North Carolina Wildlife Resources Commission

27 February 2007

This letter is in response to your letter dated 10 January 2007 requesting information on listed species and important habitats related to Progress Energy's expansion of the Harris nuclear facility. This expansion includes raising the elevation of Harris Reservoir by 20 feet which will flood approximately 4000 acres, removing water from the Carpe Fear River assist in raising the reservoir elevation, and constructing associated piping. Biologists with the North Carolina Wildlife Resources Commission (NCWRC) have reviewed your letter and offer the following comments.

Impacts of New Lake Elevation on Terrestrial Wildlife Habitat

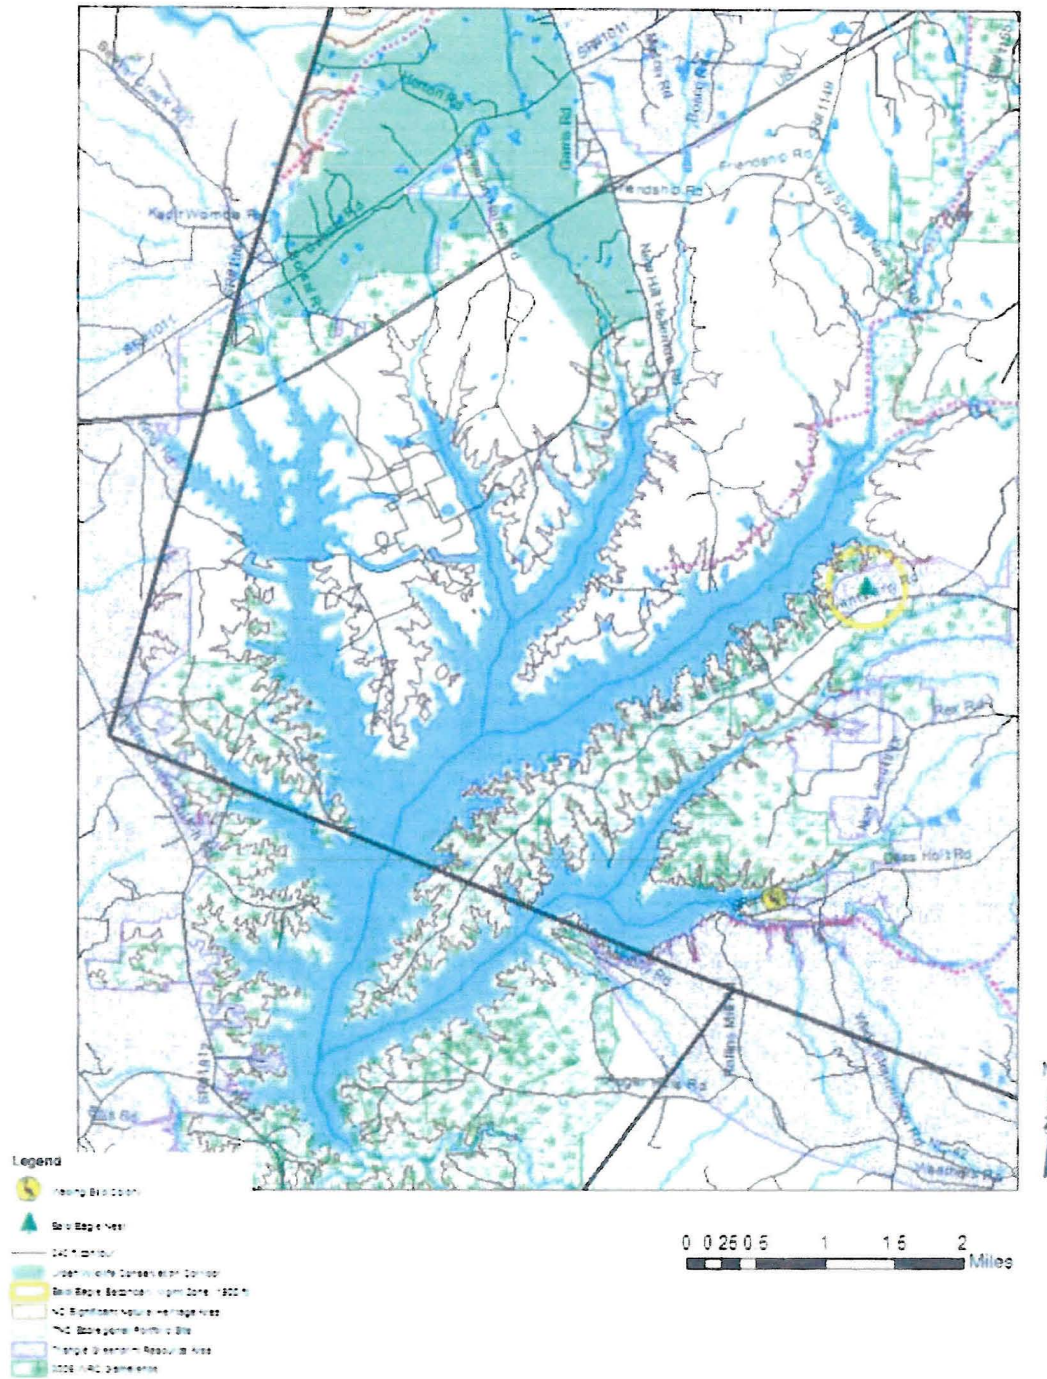
- Priority upland areas that will be partially flooded include:
 - Small portion of NCWRC's Urban Wildlife Conservation Corridor (shown in green on the attached map). This is a target area where the Urban Wildlife Project is working to piece together a wildlife travel corridor so species can migrate between Harris and Jordan Lakes.

- Portion of The Nature Conservancy's Piedmont Ecoregional Portfolio Site (shown in purple hatch marks on the attached map). Most of the land to be flooded that is not presently managed as Game Land has been designated by The Nature Conservancy as part of its Ecoregional Portfolio. This designation means the area has high environmental value.

- Priority bottomland and wetland areas that will be flooded include:
 - Wading Bird Colony (location labeled on attached map)

- Due to the lake's higher elevation, a certain percentage of land with low elevations suitable for the presence of wetland and shoreline habitat will be permanently lost.
- 2. Harris Lake's new shoreline will move within the secondary management zone of a Bald Eagle Nest near Avent Ferry Road. The altered shoreline and additional "canal" could negatively impact individuals using this nest.
 - The nest location and secondary management zone boundary (1500 ft radius from nest) are shown on the attached map.

1. Part of the transmission line will be constructed within an NC Significant Natural Heritage Area, known as Buckhorn Bluffs and Levees, which is also managed as Game Land (shown on map). Land clearing and construction activities could negatively impact the sensitive natural communities located on this site.
2. A Bald Eagle nest is located across the Deep River from Buckhorn Dam. Any construction activities or shoreline alteration could negatively impact individuals using this nest.
 - The nest location and secondary management zone boundary (1500 ft radius from nest) are shown on the attached map.
